Cobbora Coal Mine Project

Review Report

April 2013

Figure 6-1 Extract from the Australian Astronomical Observatory Submission (AAO 2012)

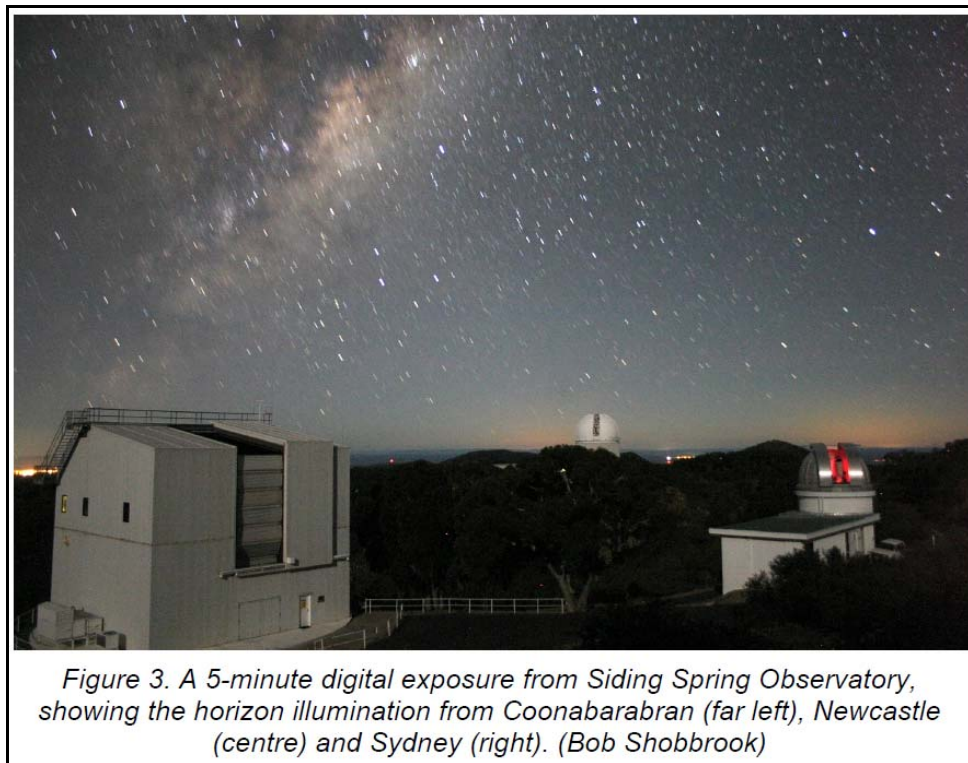
The Australian Astronomical Observatory raised two concerns regarding dust. The most obvious is that some of the additional dust generated by the mine will fall on the instruments at the Observatory adding to the cleaning requirements it must already undertake. The Observatory is some distance from the proposed mine site. While there may be some cost to the Observatory as a result of additional dust, the more significant concern, as raised at the public hearing, is that dust in the air scatters light, increasing the night time lighting impacts on the Observatory's skyline (also see Section 6.5 regarding night lighting).

The Commission acknowledges the Observatory's significance, both to the local community and to the national and international scientific community. The long term future of the Observatory will be significant both for the local economy and for Australia's scientific community. The Commission considers that every effort must be made to minimise and manage any impacts of the mine on the Observatory. Consequently it is essential that this mine employs world's best practice in regard to minimising dust emissions and night lighting. This includes day to day operations of the mine, but also extends to the design of the mine plan itself.

Figure 7-2 Mine plan year 8, showing start of encroachment on main woodland corridor

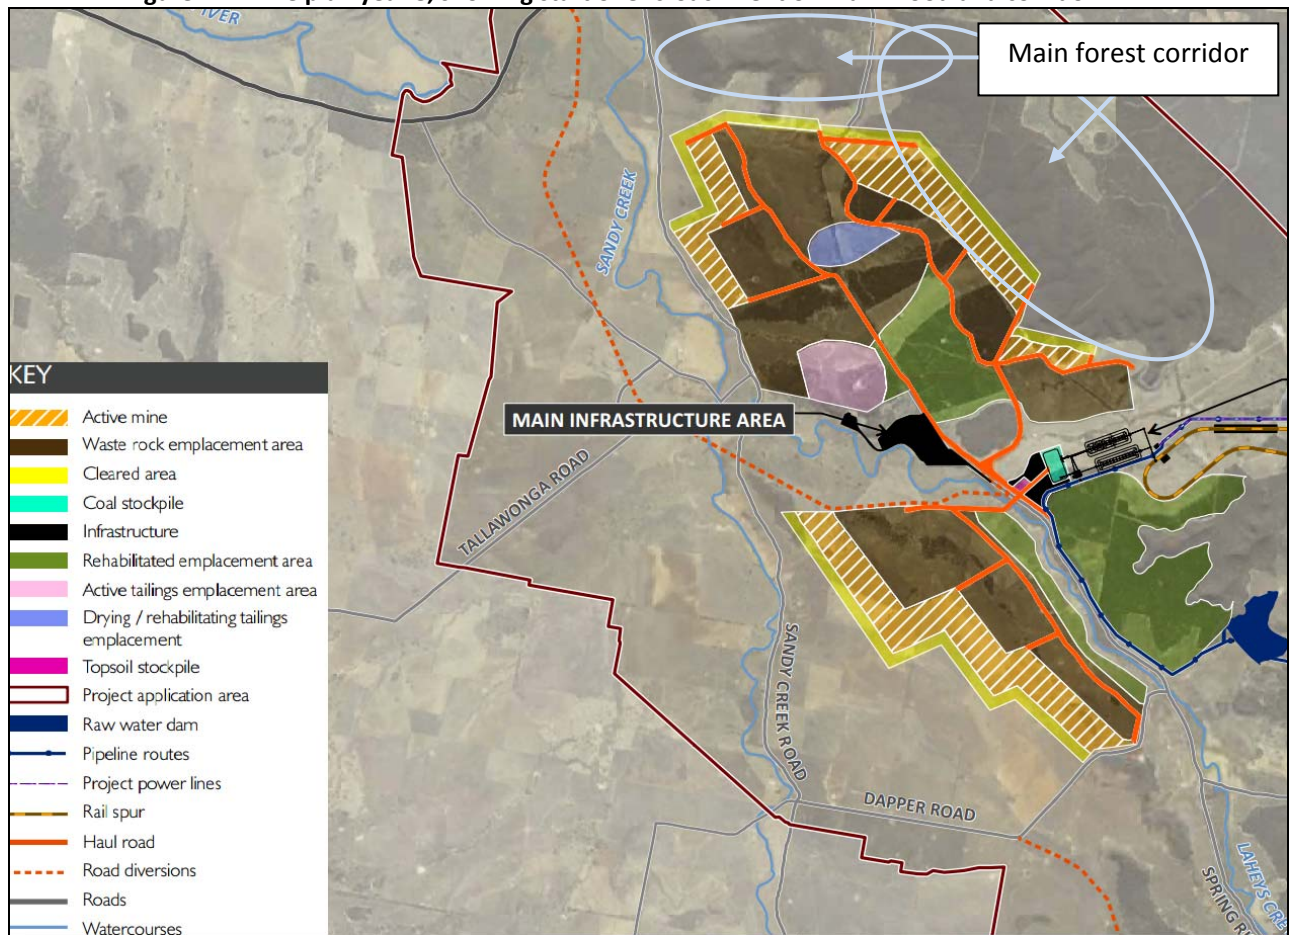
Much of the coal proposed to be mined in pit C is covered by established woodland communities and include hollow bearing trees and other valuable habitat features. Mining of pit C is proposed to start in year two and would generally progress in a north easterly direction. Consequently the Commission estimates it would take between 4 and 8 years for mining to reach the main northern woodland area (see Figure 7-2).

Figure 4.1: Annual Flow Duration Curve for the Talbragar River at Elong Elong (421042)

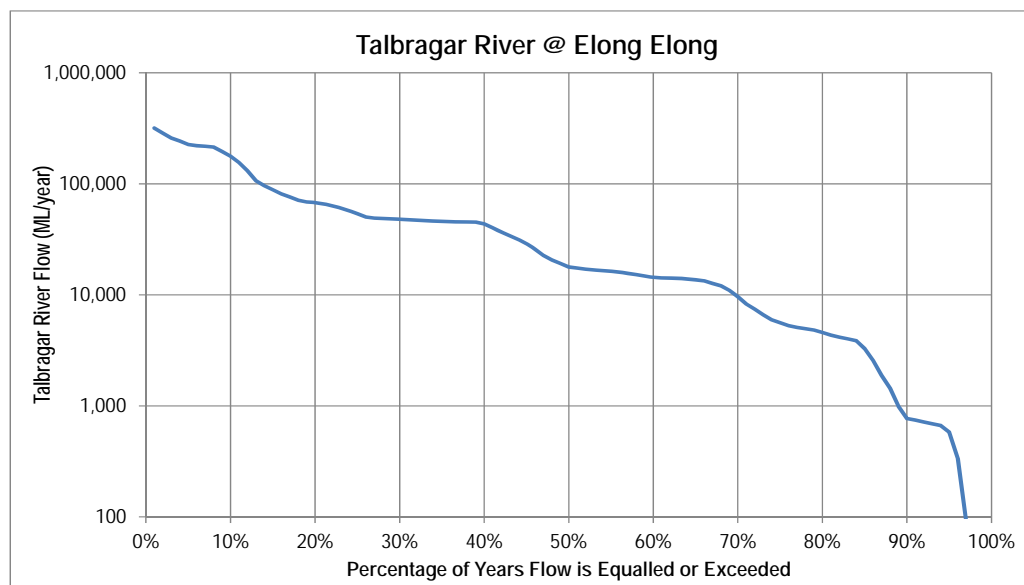
On the other hand, in Section 7.1 (page 115) of the *Groundwater Assessment*, groundwater drawdown is predicted to impact on groundwater inflow to a number of semi-permanent pools along Laheys Creek and Sandy Creek (see **Section 6.1**) and to lead to a likely maximum reduction baseflow to the Talbragar River of approximately 480 ML/a (in 2036 following the end of mining operations). The *Groundwater Assessment* considers that the impact would small, representing only 0.9% of the average annual flow.

However, this assessment overlooks the highly skewed statistical distribution of flow in the Talbragar River which is illustrated by the flow duration curve in **Figure 4.1**. For such rivers, comparison of the predicted reduction in baseflow with flow in years of relatively low flow (see **Table 4.3**) is a better indication of the predicted impact. The table shows that in a 1 in 10 low flow year the predicted reduction in baseflow could account for 62% of the flow in the river while in a 1 in 5 low flow year the reduction would be 10%. Even in a median flow year the reduction would be 2.7%.

Figure 5.1: Probability of Water Import Requirements Being Exceeded

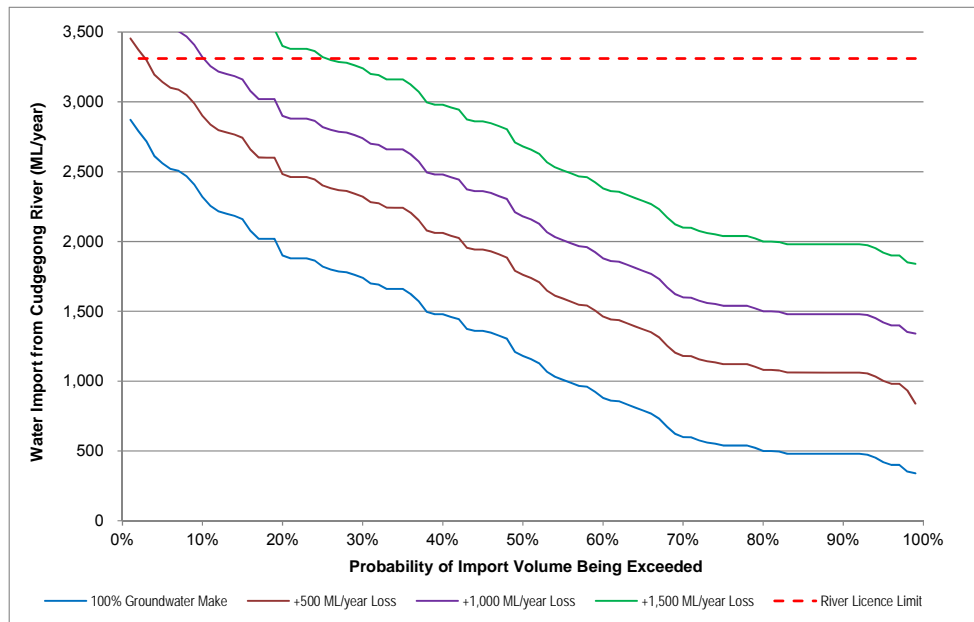
Figure 5.1 summarises the statistics for imported water supply requirements in Mine Year 20 for a ‘base case’ and scenarios with increased water losses:

- 2) Three increased loss scenarios (500, 1,000, and 1,500 ML/year) which represent situations in which there is an increased loss of groundwater before it becomes ‘available’ for use and water demands for tailings disposal, dust suppression seepage losses are higher than has been assumed. For these scenarios, the ability of the mine to meet its demands from imported water progressively decline with average annual demand for imported water increasing to 1,780 ML, 2,280 ML and 2,780 ML per year respectively. As shown on **Figure 5.1** the ability of the mine to fully meet demand from imported water would progressively decline to the point where (in the case of increased use and loss by 1,500 ML/year) there would be a shortfall in 25% of years.

The results from the increased loss scenarios indicate that, as long as the additional demand for water is less than about 500 ML/year (approximately corresponding to Mine Year 16), there is low probability that the mine would experience water shortage.

Figure 1: Simulated life-of-mine Pit water storage (1944-1964 climatic sequence)

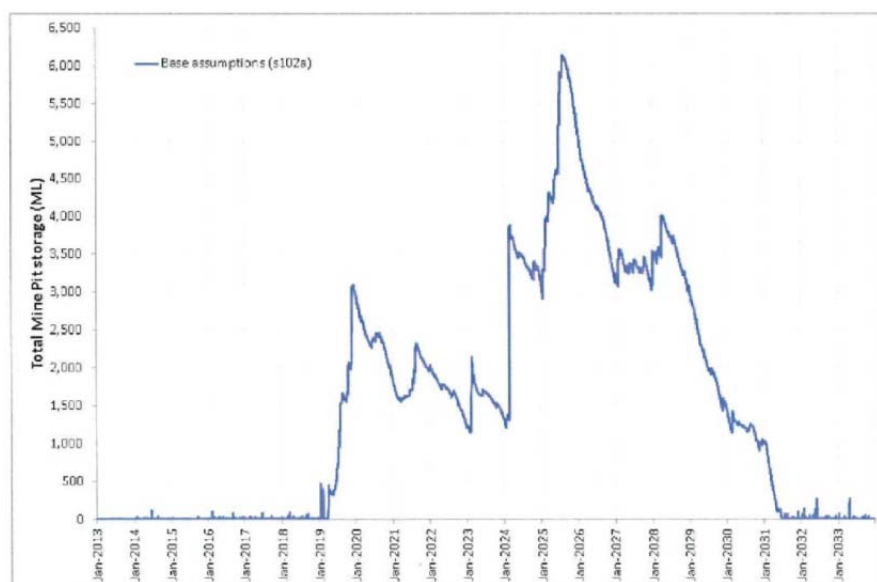
On the other hand, by only assessing the water balance for selected mine years, the analysis does not necessarily provide an accurate picture of the risk of having to retain water in the mine pits for an extended period. The annexure to the submission by Mid-Western Regional Council (7 March 2013) comprises a review of the surface and groundwater assessments prepared by Gilbert & Sutherland who prepared their own water balance model for the project. Although the modelling by Gilbert & Sutherland claims to be based on same model inputs as the *Surface Water Assessment* no data is provided to substantiate this claim. Notwithstanding, the important aspect of their modelling is that they assessed the 'life-of-mine' water balance by applying the climatic data and mine layout details on a continually evolving basis, rather than the climatic and mine layout 'snapshot' approach adopted for the *Surface Water Assessment*. Results for the example 'base case' are:

Results from the base case scenario modelling indicate extended periods where volumes of greater than 2,000 ML are required to be stored within the pits occurring within some 50% of climatic sequences assessed. Similarly, results show required total pit storages of greater than 5000 ML in some 15% of climatic sequences. Figure 1 shows an example of life of mine pit water storage behaviour for one such climatic sequence. Of particular importance is the extended and continuous period of more than 10 years with greater than 1500 ML, and more than 5 years requiring management of 3000 ML or more. Whilst the climatic conditions for this sequence are above average, they could not be considered 'extreme'.

Figure 6.1: Extract from Figure Showing Creek Crossings, Levees and 100 Year ARI Flood Extent

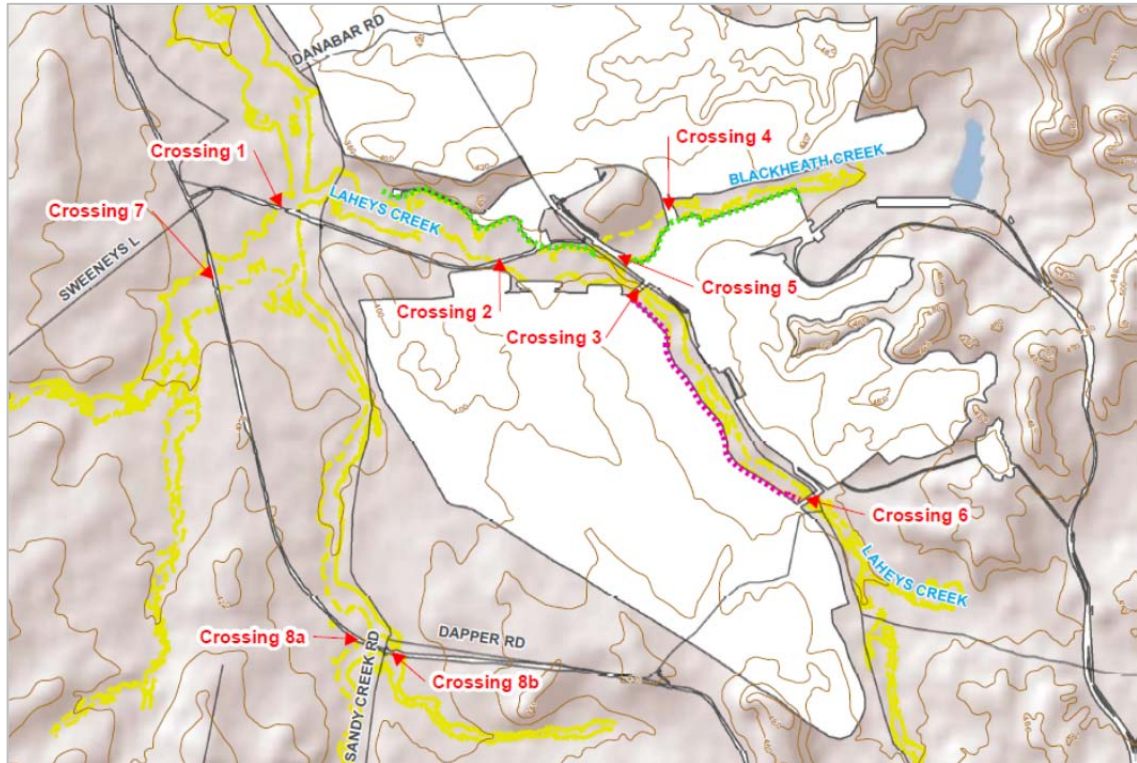
Table 7-1 in Appendix D of the *Surface Water Assessment* identifies the flood level increases at various structures. **Table 6.3** summarises these increases for the locations shown in **Figure 6.1**. The table shows that the flood level increases in the vicinity of a number of structures are predicted to be significantly greater than the adopted criteria of 0.5 m and are therefore likely to result in significant localised increases in velocity. In particular, significant flood level increases are predicted for Crossings 4 and 5 near the junction of Blackheath Creek and Laheys Creek and for Crossing 7 on Sandy Creek.

The assessment in Appendix D concludes that the areas of significant flood level increase are mainly confined to Laheys Creek and Blackheath Creek in the vicinity of the mine infrastructure area. The mining areas would be protected by flood levees (shown as green lines on **Figure 6.1**) that extend along the length of creek where flood level increases are predicted. Accordingly, the increased flood levels would not have any adverse impact. However, the assessment acknowledges that:
